**TOWN OF NEWBURGH  
PLANNING BOARD  
TECHNICAL REVIEW COMMENTS**

**PROJECT NAME:** NEWBURGH CHICKEN, LLC - POPEYES  
**PROJECT NO.:** 23-17  
**PROJECT LOCATION:** 197 SOUTH PLANK ROAD  
SECTION 60, BLOCK 3, LOT 6.1  
**REVIEW DATE:** 22 JANUARY 2024  
**MEETING DATE:** 1 FEBRUARY 2024  
**PROJECT REPRESENTATIVE:** DYNAMIC ENGINEERING

**RE: Newburgh Chicken, LLC  
Proposed Site Improvements  
Section 60, Block 3, Lot 6.1  
197 South Plan Road  
Town of Newburgh  
Orange County, NY  
DEC # 1021 22-01041**

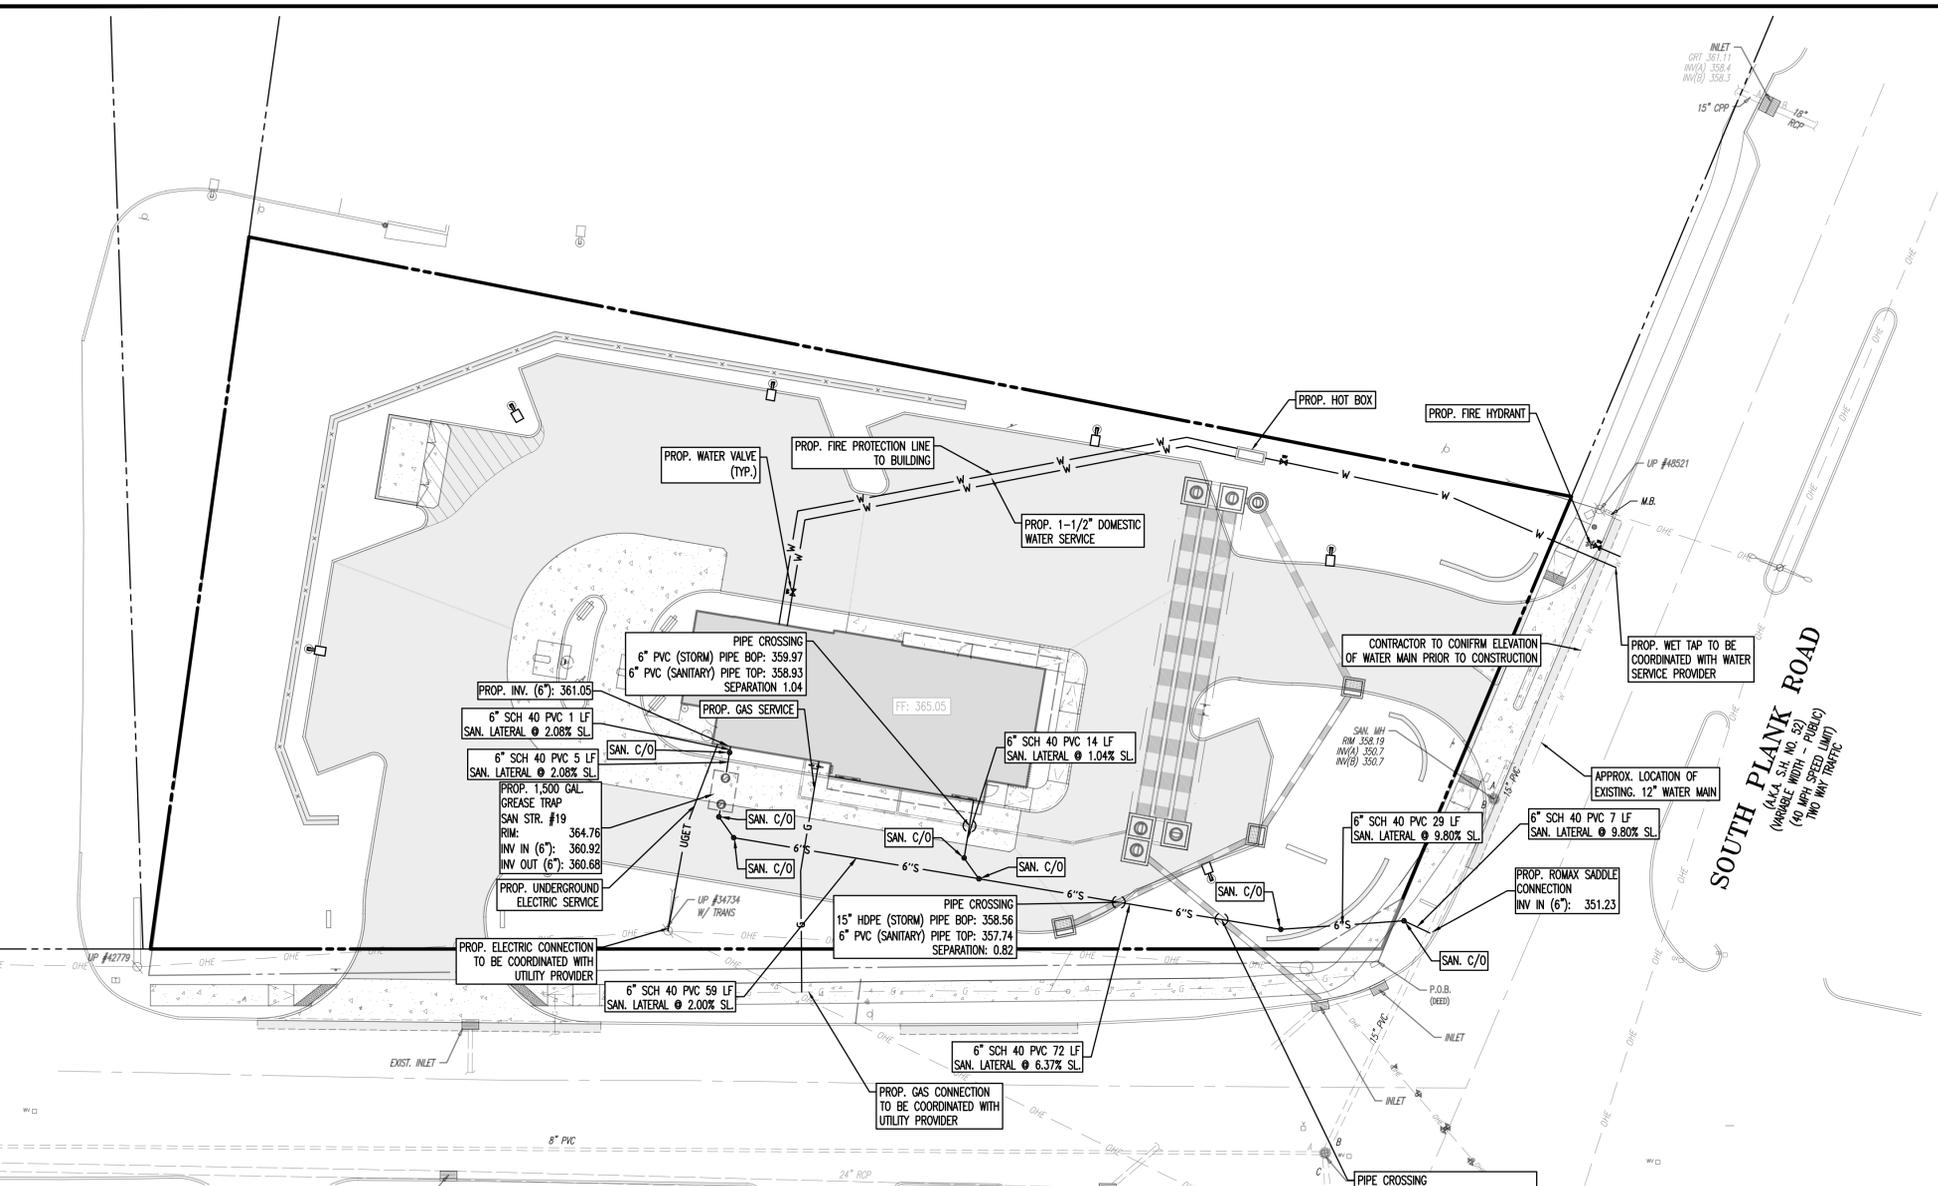
8. The proposed watermain servicing the site contains a proposed "hot box". This is not required in the Town of Newburgh. A single waterline should be proposed up to the building where the fire service and potable waterline will then split per Town details. A copy of standard detail is attached. This design requires that the potable water be terminated should fire flow to the building be terminated.

5. *The building is required to be provided with fire protection sprinklers in accordance with Chapter 107-17 thru 26. The water supply should be upgraded to provide for sprinklers. Sprinkler and potable water connections should be designed in accordance with the attached detail.*

8. *Standard notes for connection to the Town of Newburgh Water & Sewer must be added to the plans. Copy attached.*

15. *The existing Utility Notes on Sheet 8 with regard to water and sewer should state that existing water and sewer utilities are to be capped and new connections provided for the site.*

**The Utility Plan (sheet 8 of 20) has been updated to propose a fire protection sprinklers in accordance with Chapter 107-17 thru 26. Further information regarding the fire service will be provided on the building construction drawings that will be provided during submission for a Building Permit.**

**The Utility Plan (sheet 8 of 20) has been updated to include standard notes for connection to the Town of Newburgh Water & Sewer.**

**The Utility Plan (sheet 8 of 20) has been revised to include notes stating that existing water and sewer utilities are to be capped and new connections provided for the site.**

**WATER SERVICE CONNECTION**  
NOT TO SCALE

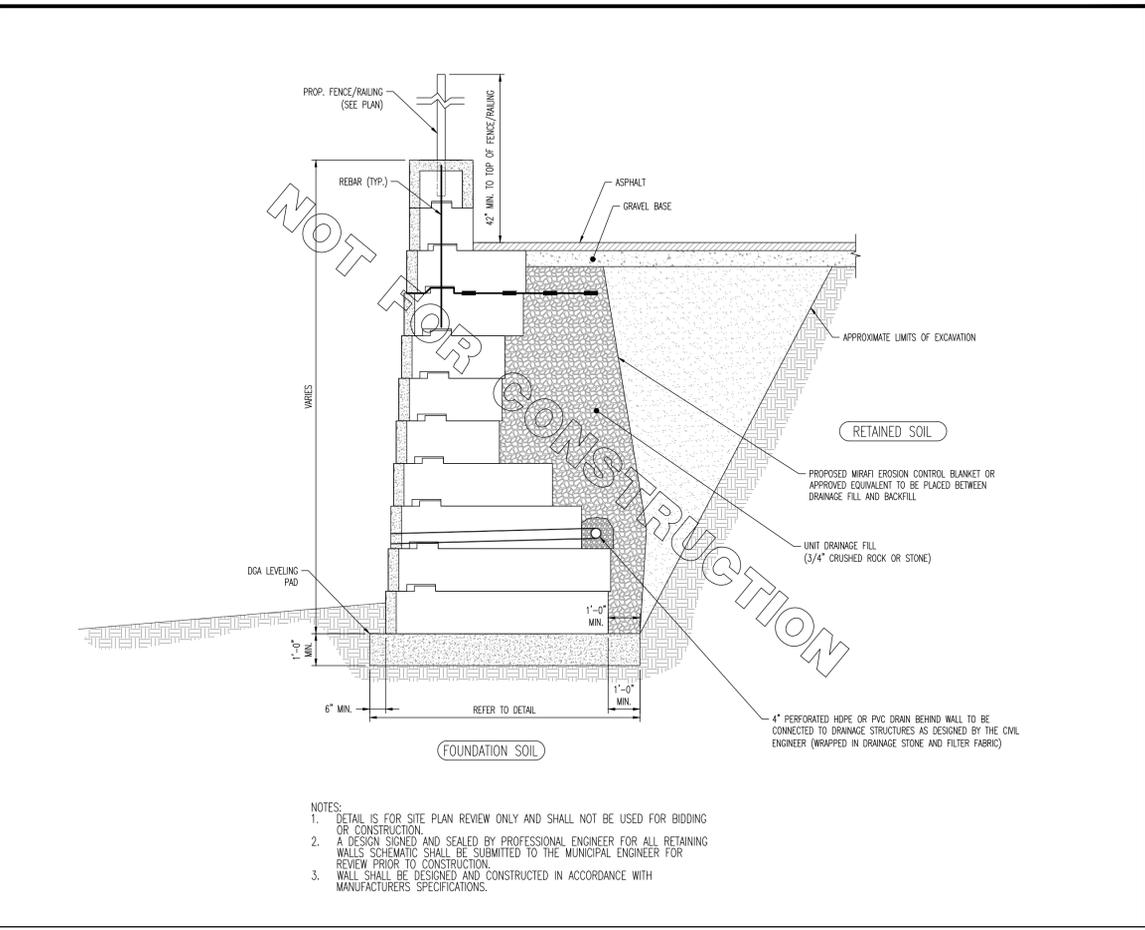
9. A lighting plan has been prepared identifying the fixture light poles at 18-feet high.
10. Water service details should be upgraded with regard to providing a single pipe for fire flow with potable water to be taken from that.

**SCHEMATIC GRAVITY BLOCK RETAINING WALL DETAIL**  
NOT TO SCALE

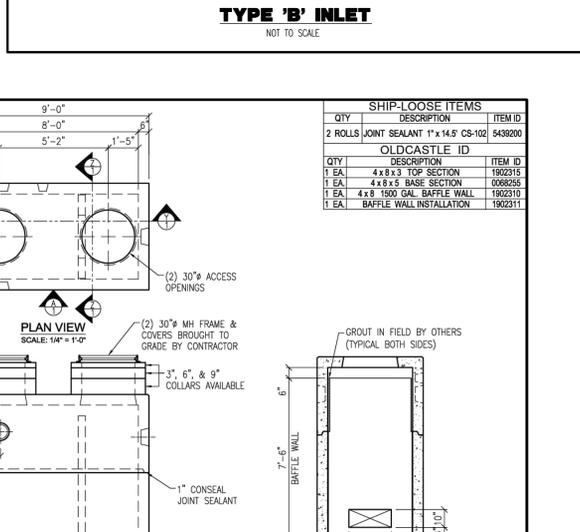
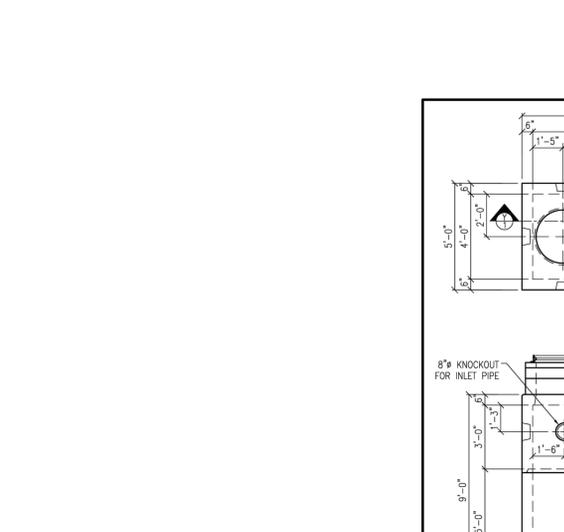
2. *Because proposed retaining walls on site are so tall, geogrid may be needed as part of the design of the walls. There are existing trees along the southern property line that provide screening and greenery to this stretch of Route 300. If geogrid is needed, trees will need to be removed from the top of the proposed retaining wall which would negatively affect visual impacts of the site. Please also record the size and species of trees on the neighboring property within 10' of the property line to help determine if the trees will survive and be stable once the geo-grid for proposed walls is installed. Accurately show clearing limit lines, taking into account the area needed for geo-grid.*

**The Site Plan (sheet 4 of 20) has been revised to propose a gravity block retaining wall, which will not require a geogrid and therefore, will have less impact on the surrounding trees. A full tree survey is being conducted and will be provided under separate cover on a future technical revision of the Site Plan drawings.**
